**MASTER DEVELOPMENT DRAINAGE PLAN
AMENDMENT No. 2**

**For
CORVALLIS**

August 2026

Project No. 23.1415.002

**OVERALL
DEVELOPMENT
PLAN (1)**

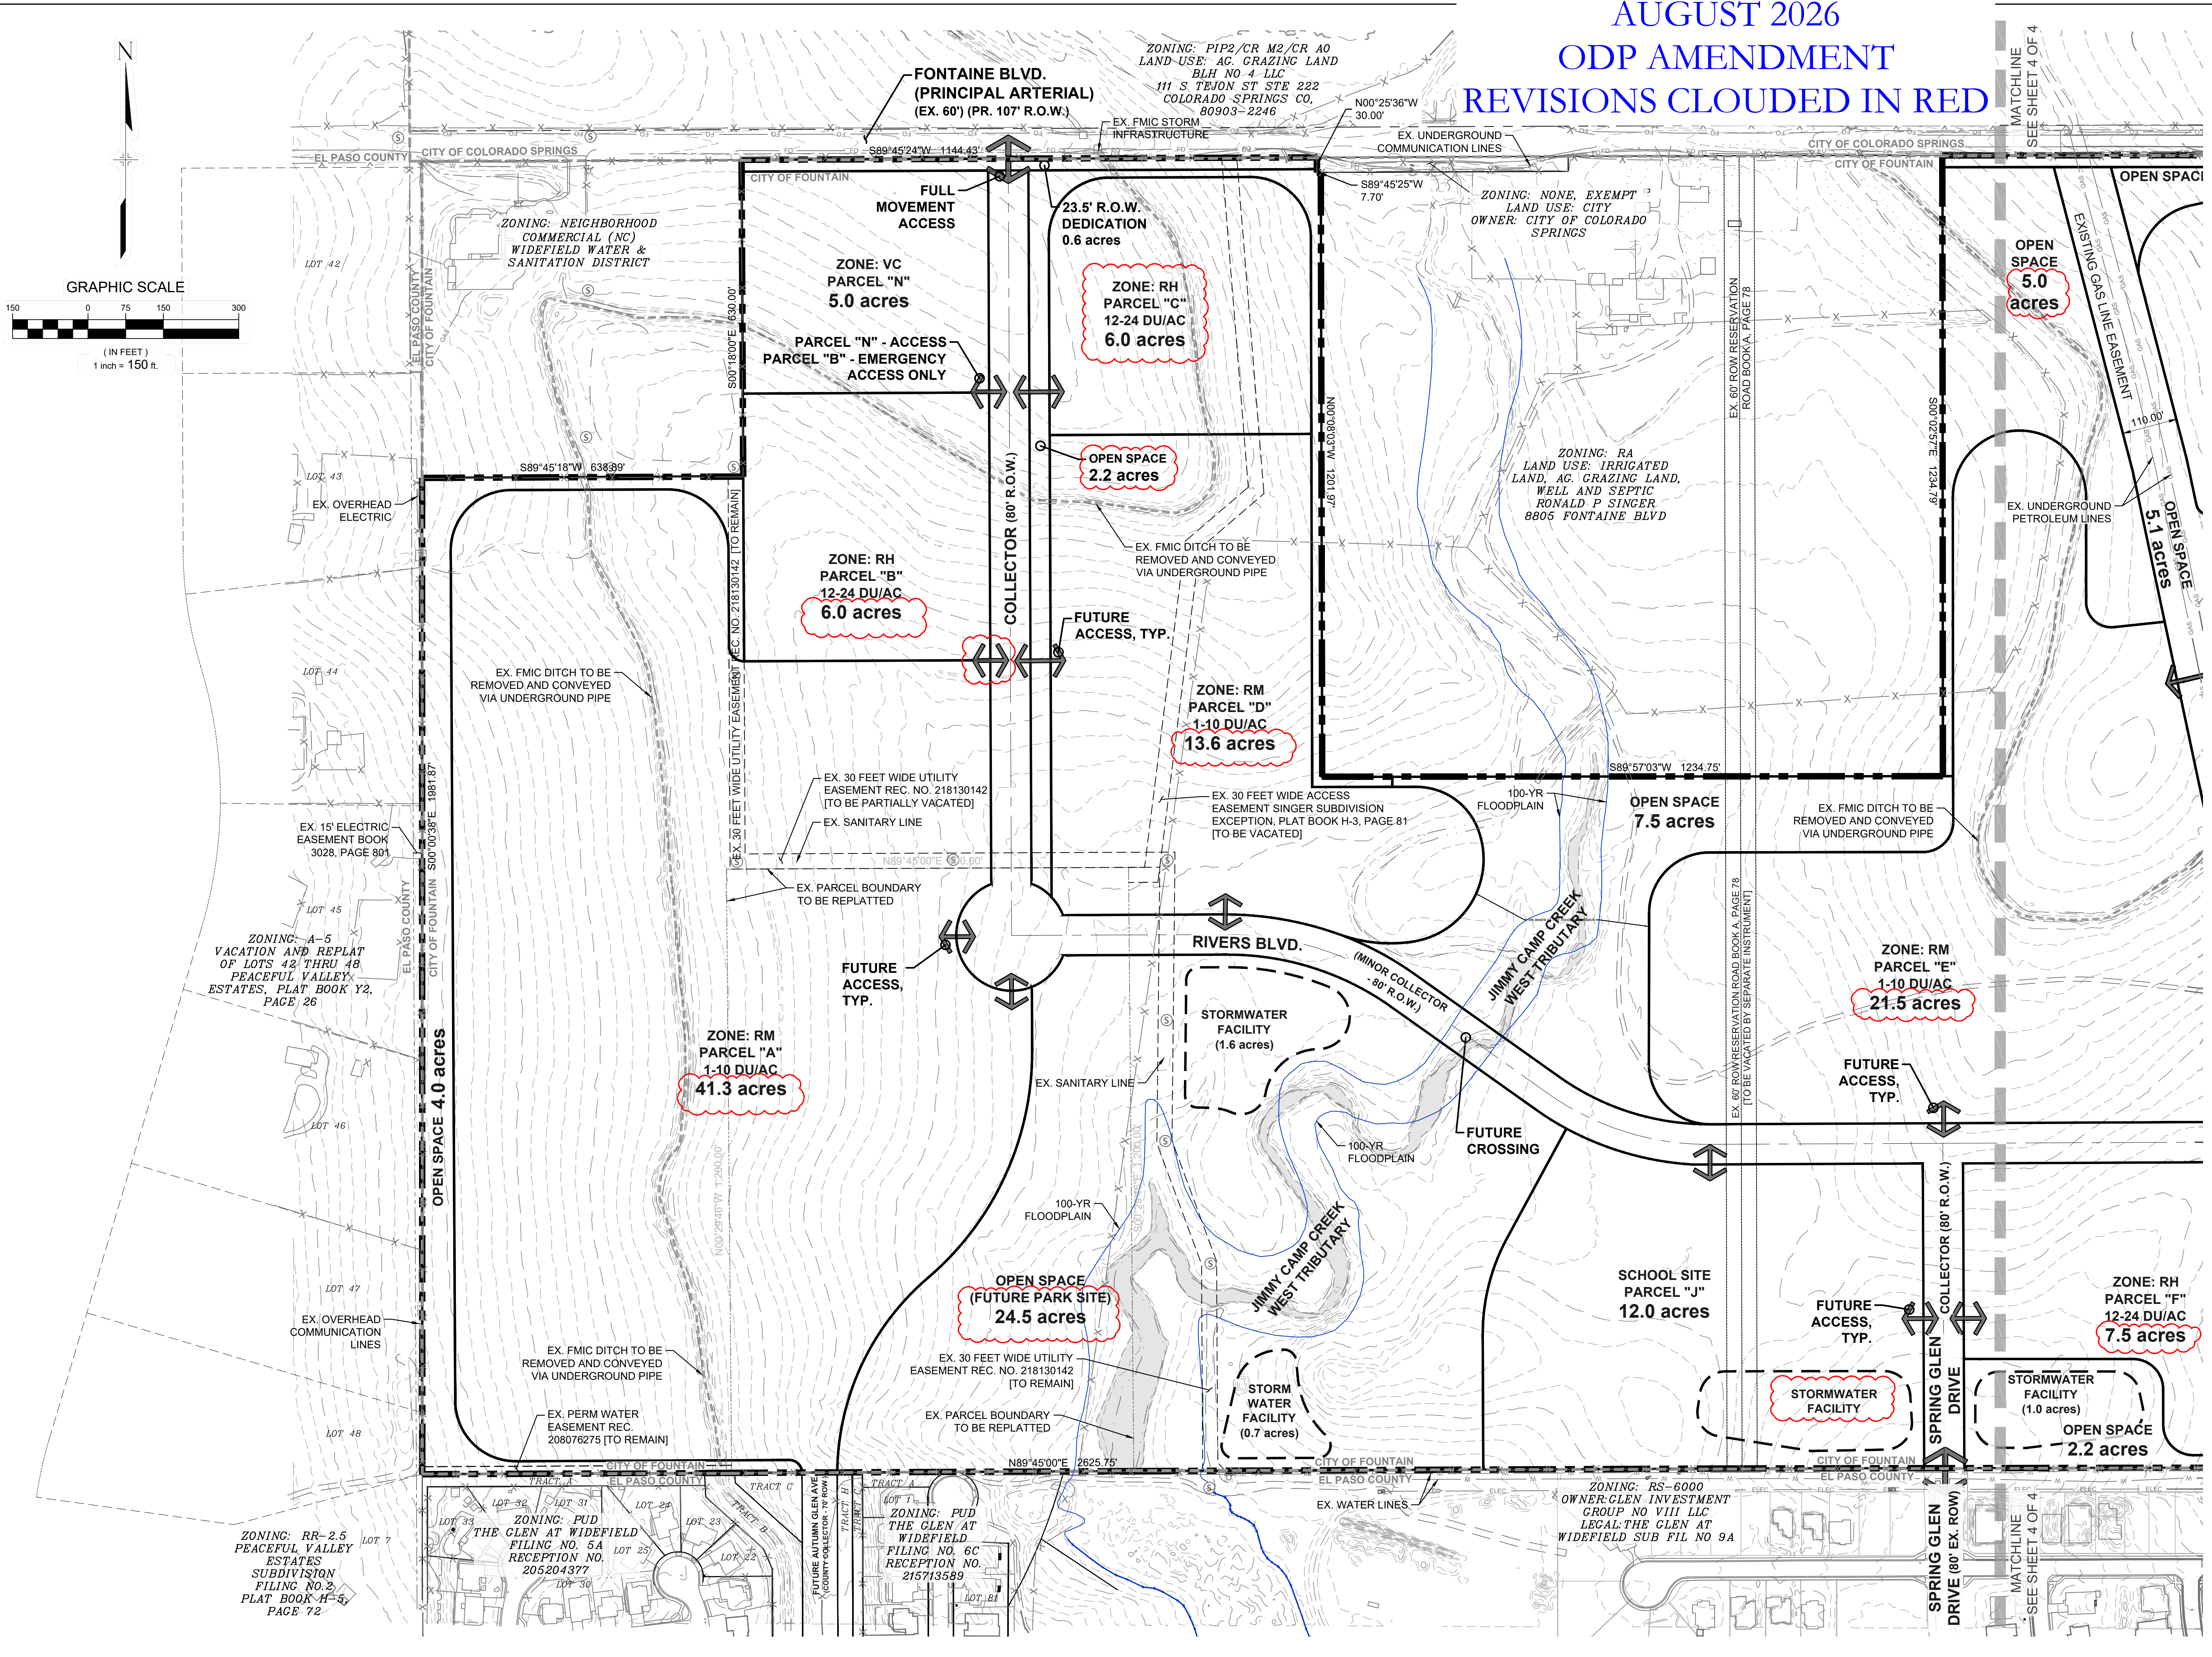
The changes summarized above do not affect drainage enough to substantially alter the analysis for the site and are in large part associated with the areas covered by the detention and FMIC Irrigation Ditch facilities included in the original MDDP and Lacey Parcel MDDP Amendment. Development filings within Corvallis will be required to provide Final Drainage Reports to provide a more detailed design and analysis of the relevant site infrastructure.

AUGUST 2026
ODP AMENDMENT
REVISIONS CLOUDED IN RED
